Subject: Supplemental Information Regarding License Amendment Application to Add a New Technical Specification 3/4.7.1.8, Main Feedwater Control Valves and Startup Feedwater Control Valves, and Associated Bases (License Amendment Request No. 98-0014; TAC No. MA9560)

SUPPLEMENTAL INFORMATION
IN SUPPORT OF
APPLICATION FOR AMENDMENT
TO
FACILITY OPERATING LICENSE NPF-3
DAVIS-BESSE NUCLEAR POWER STATION
UNIT NUMBER 1

Risk Assessment of Proposed Technical Specification 72-Hour Allowed Outage Time for Main Feedwater Control Valves and Startup Feedwater Control Valves

Main Feedwater System Control and Isolation Valves

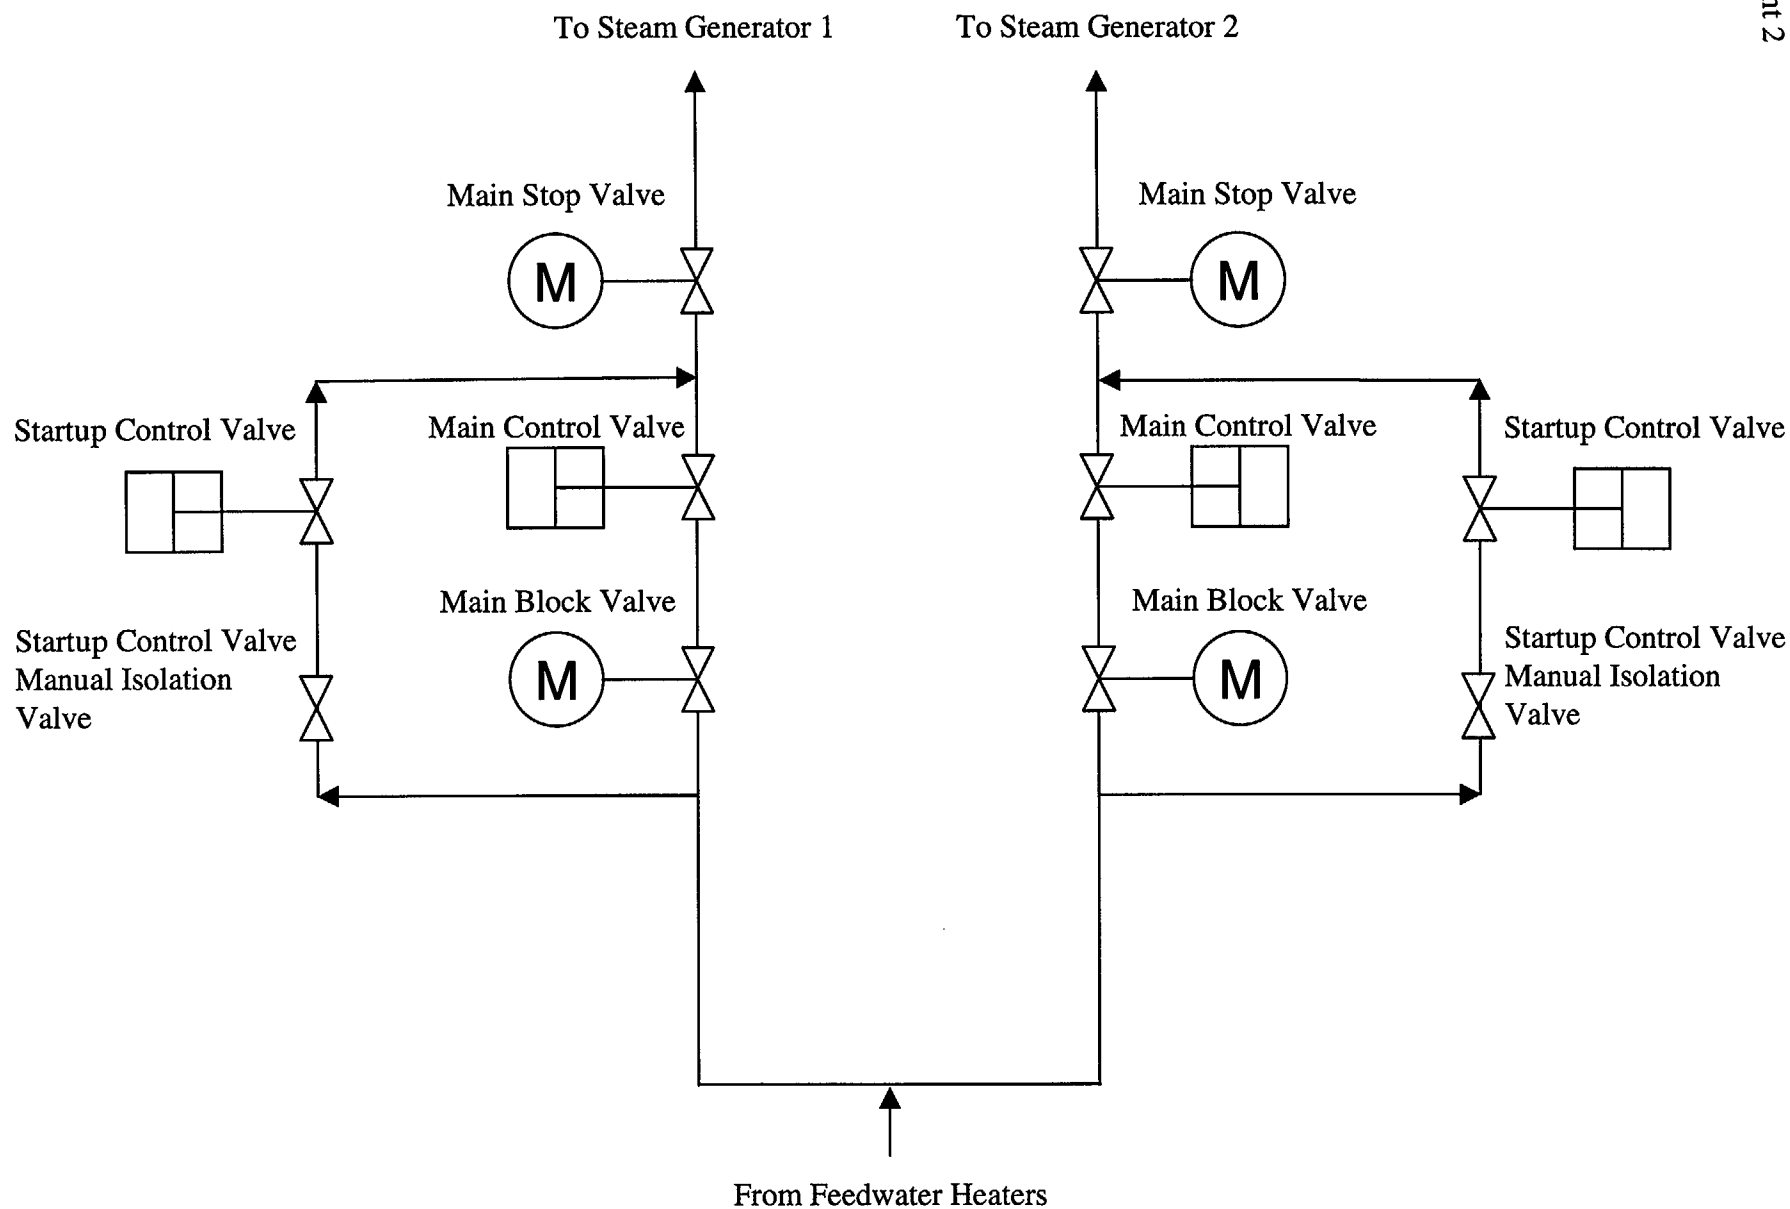
During a telephone conference call held on December 19, 2000, between the Davis-Besse Nuclear Power Station (DBNPS) and Nuclear Regulatory Commission (NRC) staffs, information was discussed regarding the proposed allowed outage times in License Amendment Request (LAR) 98-0014 (DBNPS Letter Serial Number 2663, dated August 7, 2000). Specifically, the NRC staff requested supplemental information with regards to the 72-hour allowed outage time in proposed Technical Specification 3/4.7.1.8, Main Feedwater Control Valves and Startup Feedwater Control Valves, and the low probability of an event occurring during this time period that would require isolation of these flow paths. The requested information is contained in Attachment 2 to this letter.

- No credit was taken for any means of isolating feedwater to the steam generator with the inoperable MFCV or SFCV, except the Main Feedwater Stop Valve (MFSV) (see attached figure).
- A conditional core damage probability of one, given overfeeding of a depressurized steam generator, was used. This is very conservative, since other actions (e.g., stopping main feedwater pumps) could be taken to mitigate the overfeeding event.
- The unavailability of any one valve was assumed to be 72 hours, the proposed allowed outage time. It should be noted that these valves are not routinely taken out of service for maintenance. Entry into the proposed Technical Specification Actions is expected to be infrequent.

The event that the Main Feedwater Control Valves (MFCVs) and Startup Feedwater Control Valves (SFCVs) are required to mitigate is a secondary-side rupture causing the depressurization of a steam generator. The value used in the Davis-Besse Nuclear Power Station (DBNPS) Probabilistic Safety Assessment (PSA) for the frequency of a rupture that would cause a steam generator to depressurize is $5.7\text{E-}04/\text{year}$. The DBNPS plant-specific failure probability for a Motor Operated Valve, such as a MFSV, is $1.79\text{E-}03$.

With an MFCV or an SFCV out of service, the steam generator isolation failure frequency can be calculated as follows:

$$\text{Isolation Failure Frequency} = (5.7\text{E-}04 / \text{year}) \times (1.79\text{E-}03)$$

$$\text{Isolation Failure Frequency} = 1.02\text{E-}06 / \text{year}$$

The frequency above does not consider the conditional probability that the event would lead to core damage. However, the bounding case can be taken and this probability assumed to be one. Assuming 72 hours of MFCV or SFCV unavailability, the incremental conditional core damage probability (ICCDP) can be calculated as follows:

$$\text{ICCDP} = (1.02\text{E-}06 / \text{year}) \times (3 \text{ days} / 365 \text{ days/year})$$

$$\text{ICCDP} = 8.38\text{E-}09$$

Regulatory Guide 1.177, *An Approach for Plant-Specific, Risk-Informed Decisionmaking: Technical Specifications*, dated August 1998, considers a value of less than $5.0\text{E-}07$ as being small. The calculated ICCDP of $8.38\text{E-}09$ is much less than the value of $5.0\text{E-}07$. Therefore, the risk impact of a MFCV or SFCV being unavailable for the proposed 72-hour allowed outage time is considered negligible and acceptable.
